### MILWAUKIE PLANNING COMMISSION Tuesday, October 13, 2015, 6:30 PM

- 5.0 **Public Hearings** – Public hearings will follow the procedure listed on reverse
  - 5.1 Summary: Riverway Ln Pool/Slope Project  
Applicant/Owner: Gary Klein  
Address: 10795 SE Riverway Ln  
File: NR-2015-003  
Staff: Brett Kelter

**To:** Planning Commission

WQR Impacts

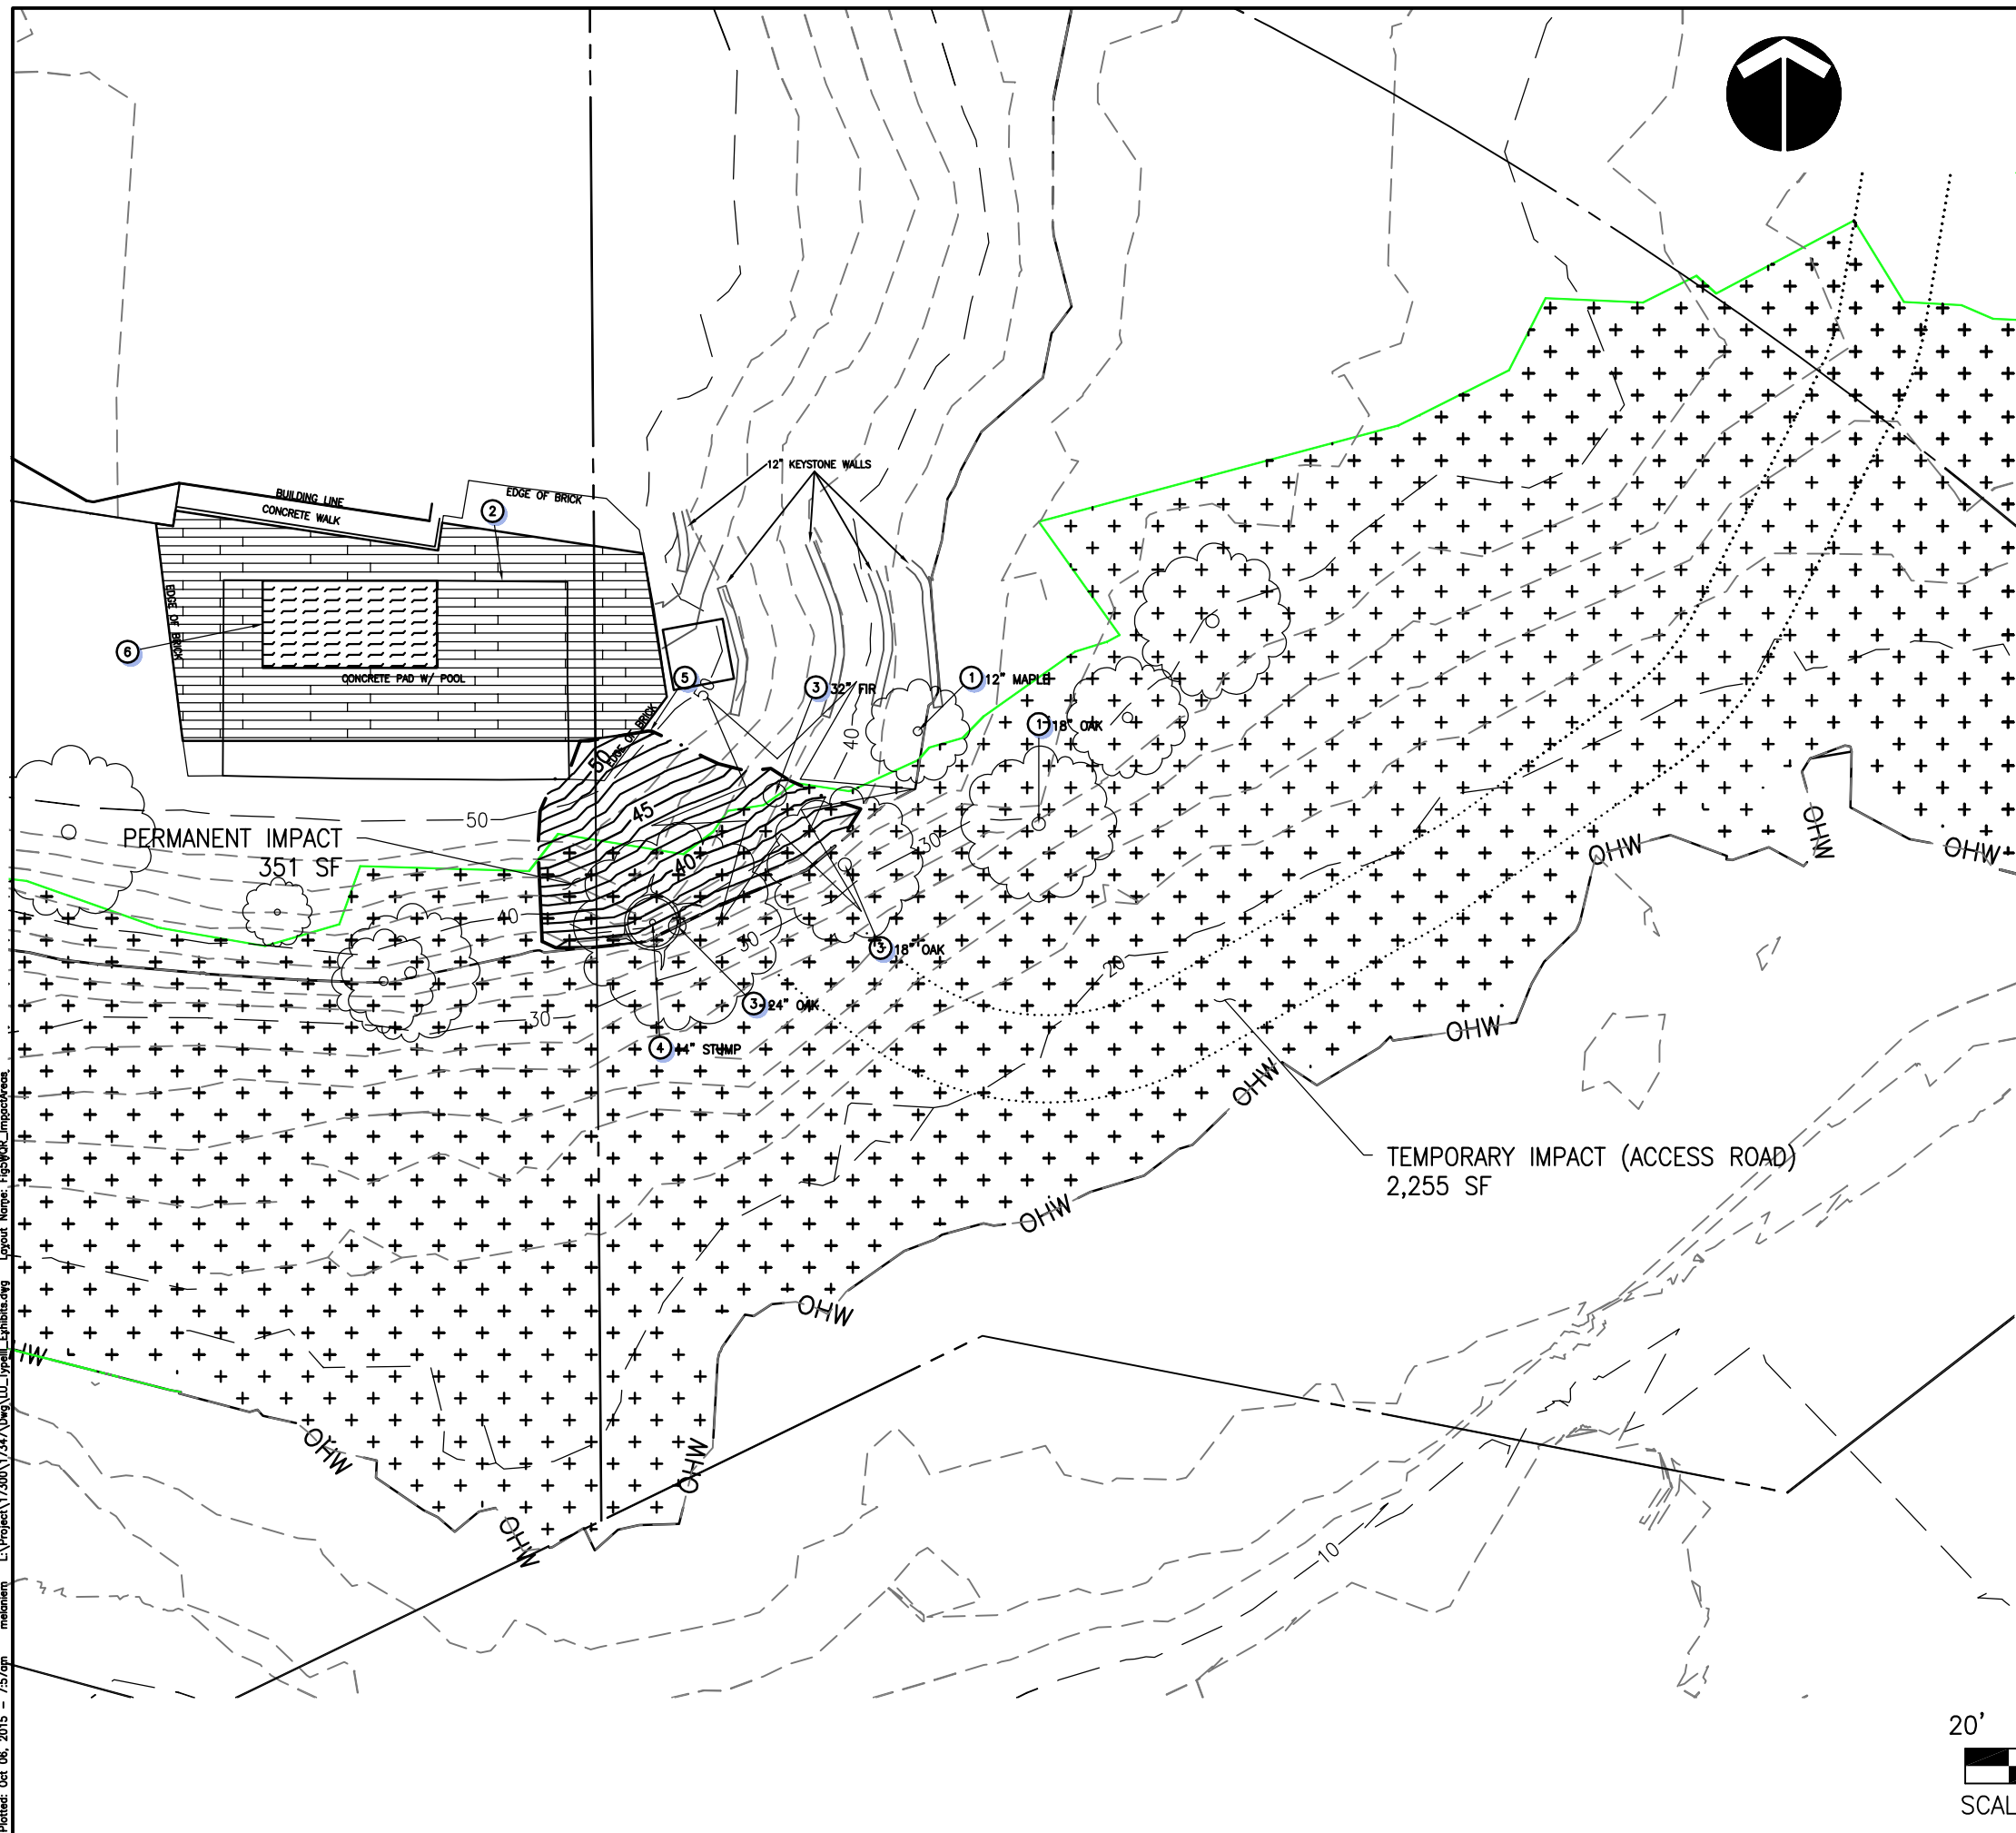
- Provide revised versions of key site plans, adjusting the representations of the location of Water Quality Resource (WQR), Habitat Conservation Area (HCA), and Willamette Greenway vegetation buffer.
- Provide an adjusted figure for WQR and HCA disturbance and a recalculation of mitigation plantings, at the ratio of 5 trees and 25 shrubs per 500 sq ft of disturbance.
- Provide a planting site plan showing the general locations and/or distributions of the various species, to ensure that species are located appropriately for the site conditions based on their various characteristics. The plan shall demonstrate that, to the greatest extent practicable, trees removed from the project area will be left within the WQR and/or HCA, to preserve the riparian habitat functions the downed trees would serve if left to fall naturally over time.

2) WQR Impacts, revised (Figure 5)	<input type="checkbox"/>	<input checked="" type="checkbox"/>	<input checked="" type="checkbox"/>	<input checked="" type="checkbox"/>

- (4) Preliminary HCA Impacts (Figure 4 in Impact Evaluation)
  - (5) WQR Impacts (Figure 5 in Impact Evaluation)
  - (6) Willamette Greenway Vegetation Buffer Impacts (Figure 1 in Mitigation Plan)

- (7) Mitigation Activities (Figure 2 in Mitigation Plan)
  - (8) Construction Management Plan (Figure 1)
- e. Based on the revised site plans noted in Condition 1-d, provide an adjusted figure for WQR and HCA disturbance and a recalculation of mitigation plantings, at the ratio of 5 trees and 25 shrubs per 500 sq ft of disturbance.

Henmi Global Partner  
806 SW 3RD Ave., Suite 300  
Portland, OR 97204  
Phone: (503) 287-6825  
Fax: (503) 415-2304  
www.otak.com  
17347  
Project No. Drawing No.  
**Figure 1**  
Sheet No.  
© 2014 Otak, Inc.

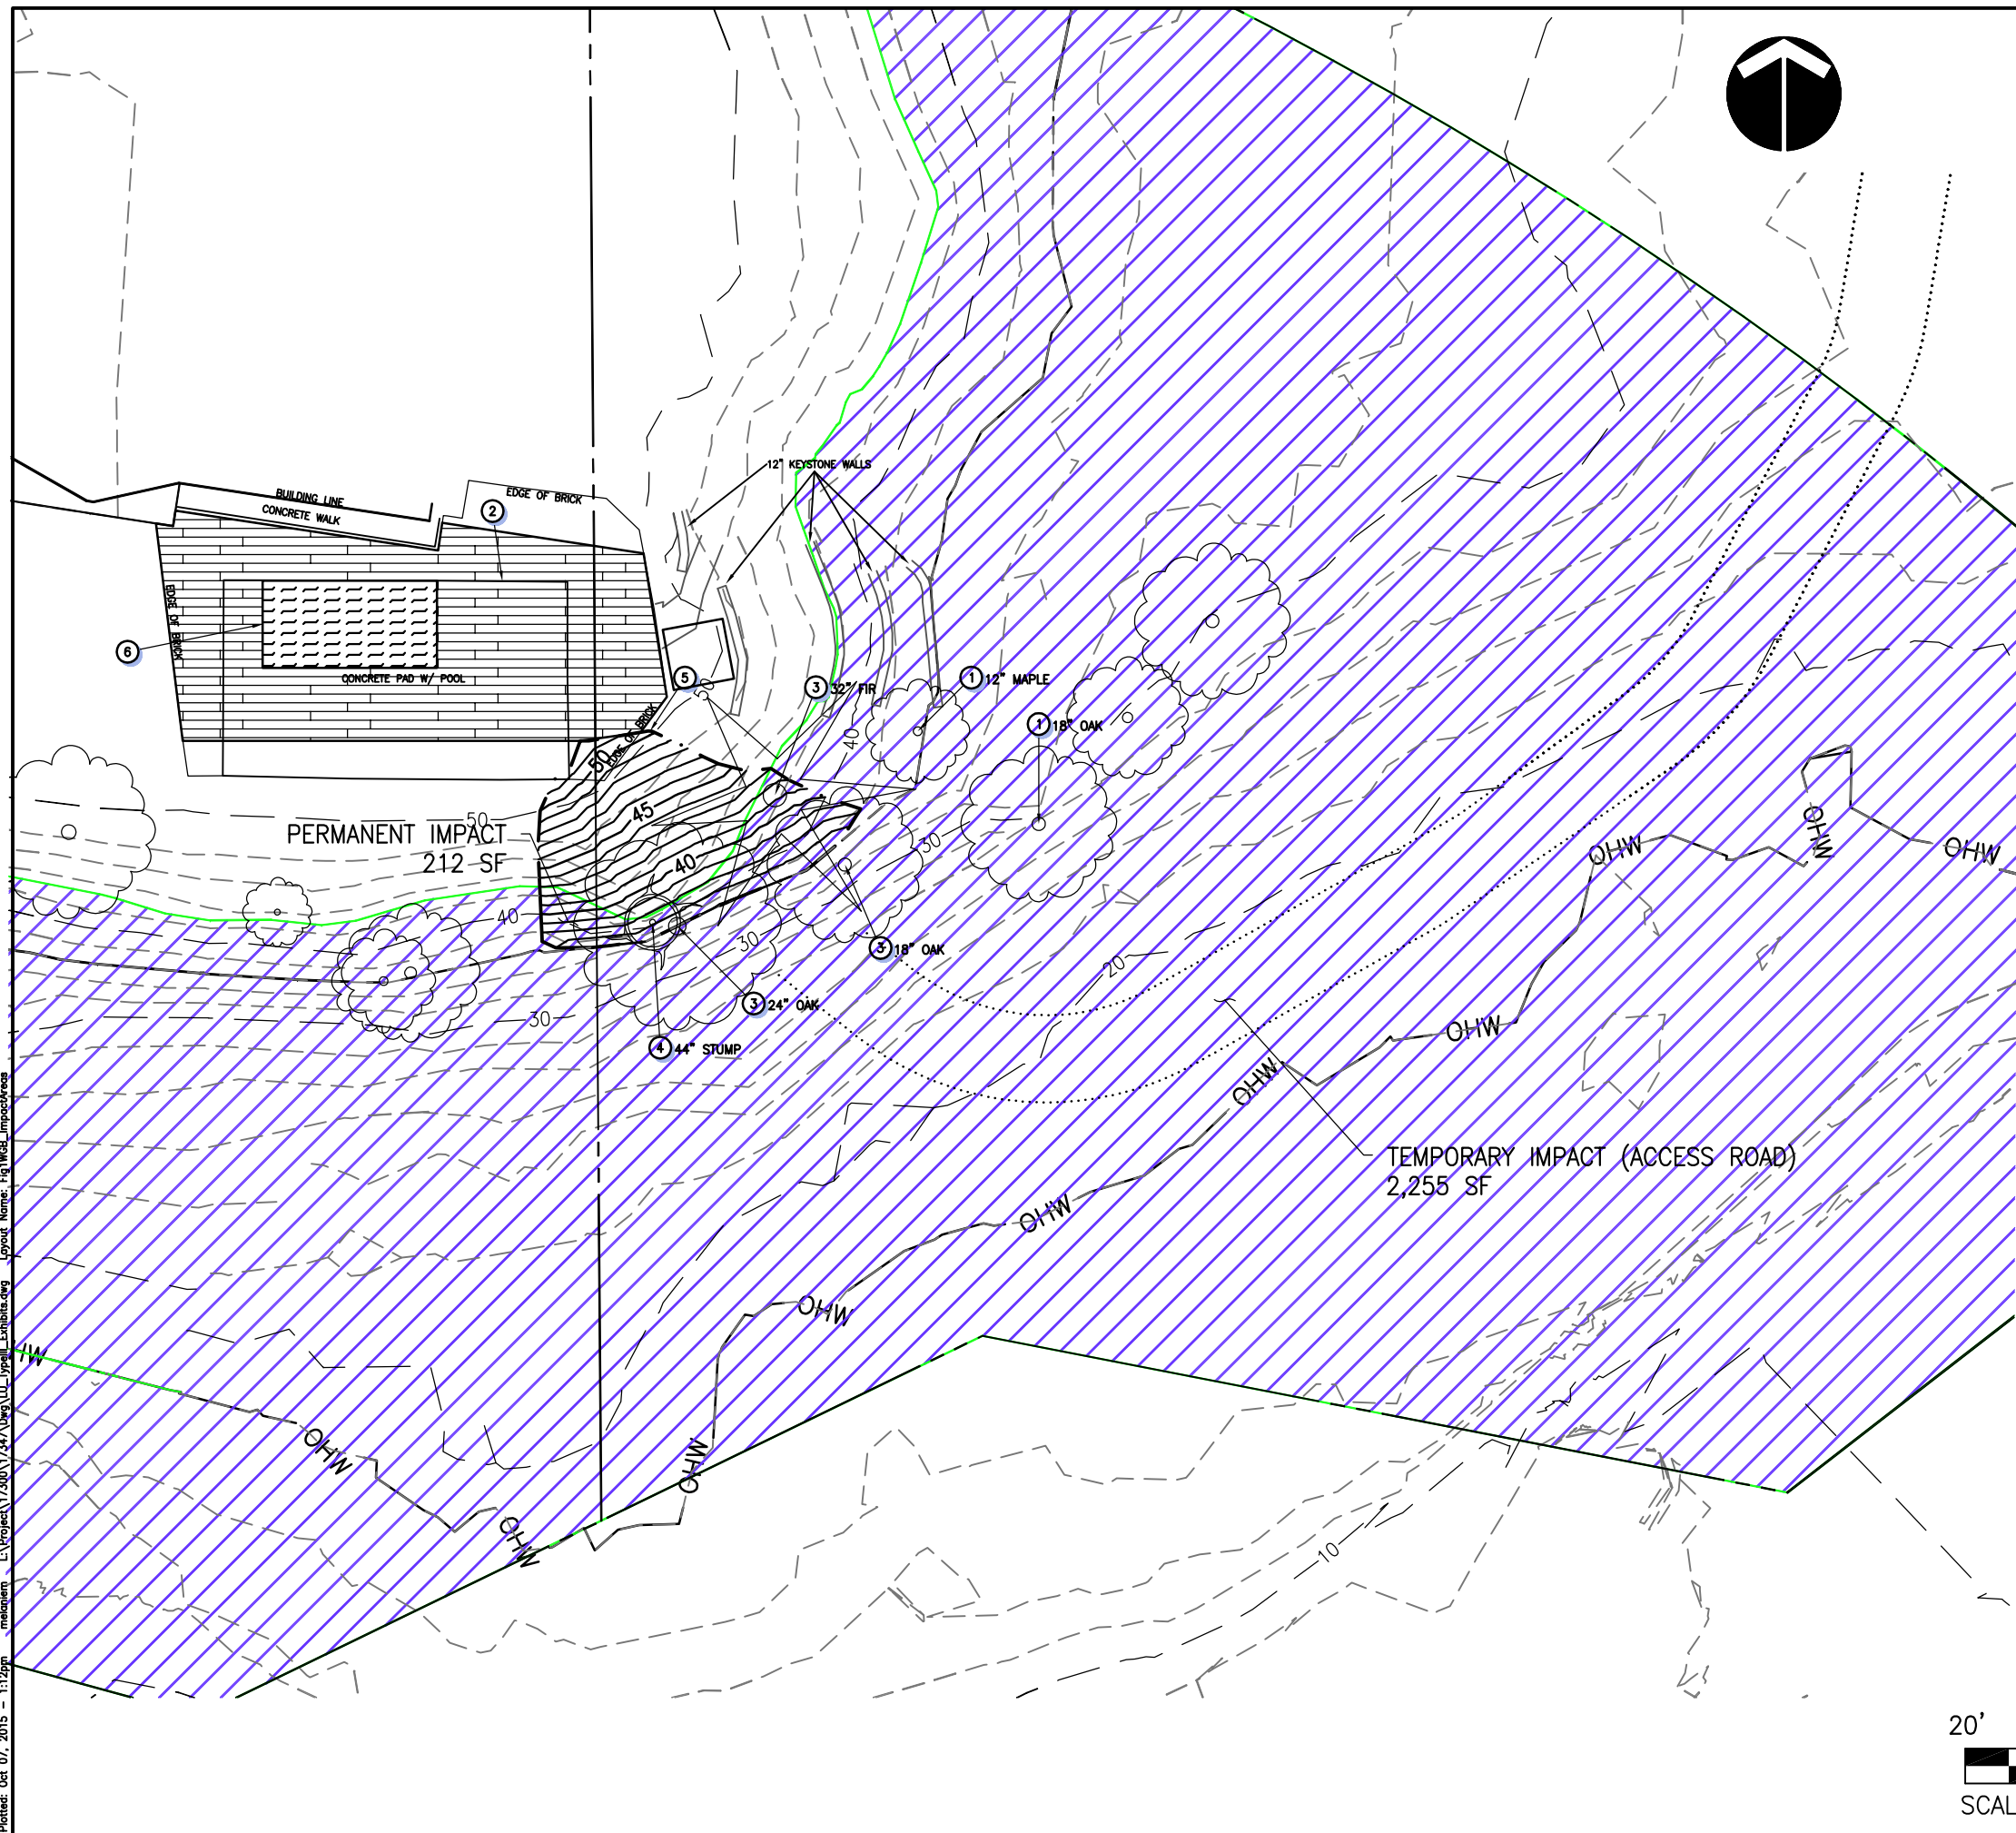
1) Willamette Greenway Vegetation Buffer Impacts, revised (Figure 1)	<input type="checkbox"/>	<input checked="" type="checkbox"/>	<input checked="" type="checkbox"/>	<input checked="" type="checkbox"/>
